FERC -
pipeline Design
+ Capacity -
Comments of

Alaskan Northwest Natural Gas)
Transportation Company---) Docket No. CP78-123, et al.
Pipeline Design and Capacity)

COMMENTS OF THE STATE OF ALASKA

COMMENTS OF THE STATE OF ALASKA ON THE
DESIGN SPECIFICATIONS AND INITIAL SYSTEM
CAPACITY OF THE ALASKAN SEGMENT OF THE
ALASKA HIGHWAY PIPELINE PROJECT

PHASE ENVELOPE FOR MIXTURE CONTAINING
ALL OF THE ETHANE AND PROPANE AND
50% OF THE BUTANES AVAILABLE FROM
PRUDHOE BAY SEPARATOR OFF-GAS

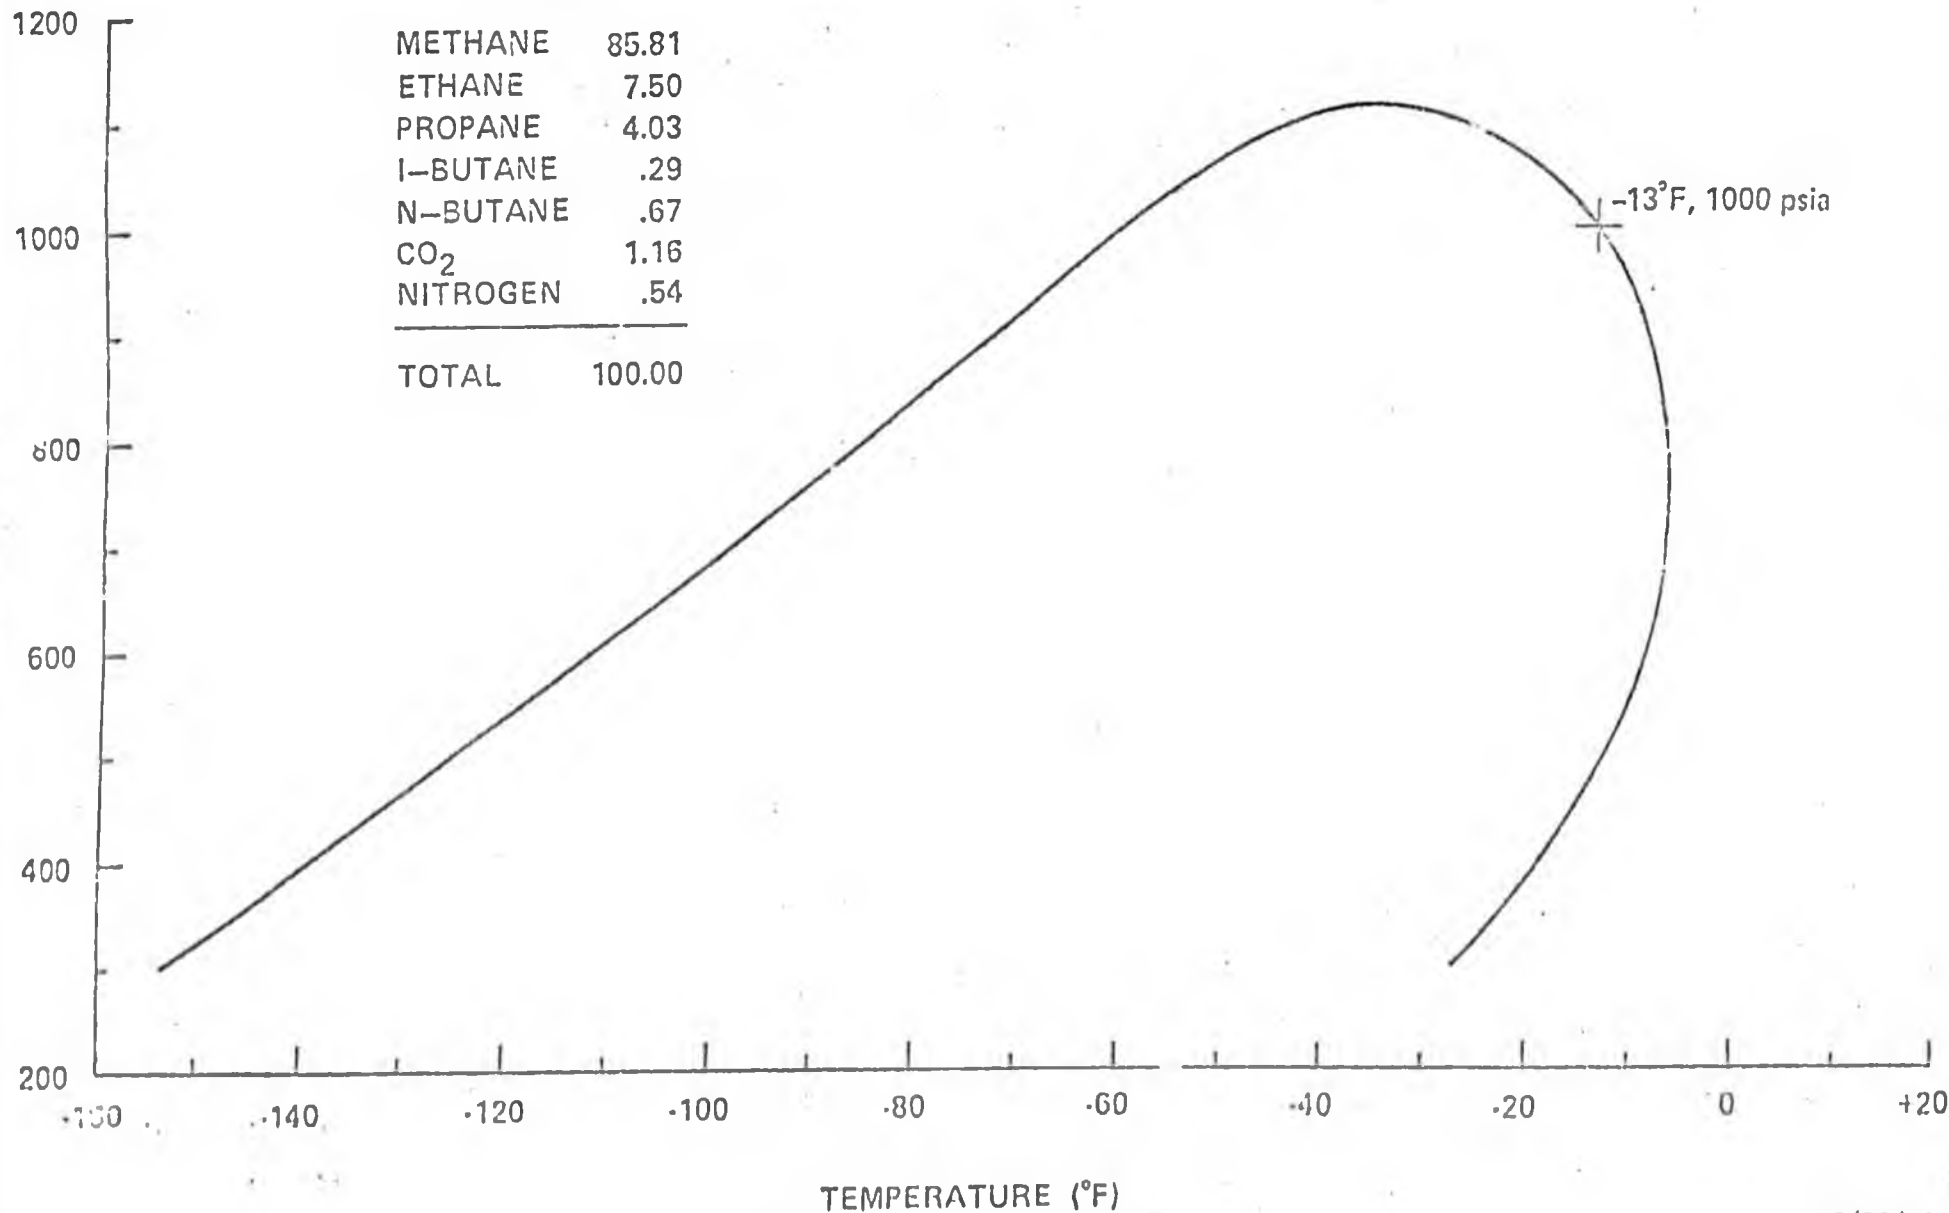
Exhibit II shows the phase envelope for a gas composition based on reducing the carbon dioxide content and removing the liquids shown in Column (d) of Exhibit I but retaining all of the ethane and propane in the pipeline gas stream. As described previously, this composition will be affected by the process utilized to condition the gas. For example, some amount of ethane and propane will be removed from the raw gas and consumed as local fuel irrespective of the gas conditioning process method actually employed. Any such reduction in ethane and/or propane content of the sales gas allows some additional butanes to be carried in the gas pipeline without exceeding the hydrocarbon dew point specification. However, this illustration shows the theoretical maximum amount of ethane and propane that could be made available to the pipeline. It can be seen that this mixture meets the required hydrocarbon dew point specification of -10°F , 1000 psia required to prevent retrograde condensation in the transmission system. A similar phase envelope for a similar mixture was previously submitted by EXXON to FERC April 3, 1978 (Figure 2, Curve 2 of the EXXON response).
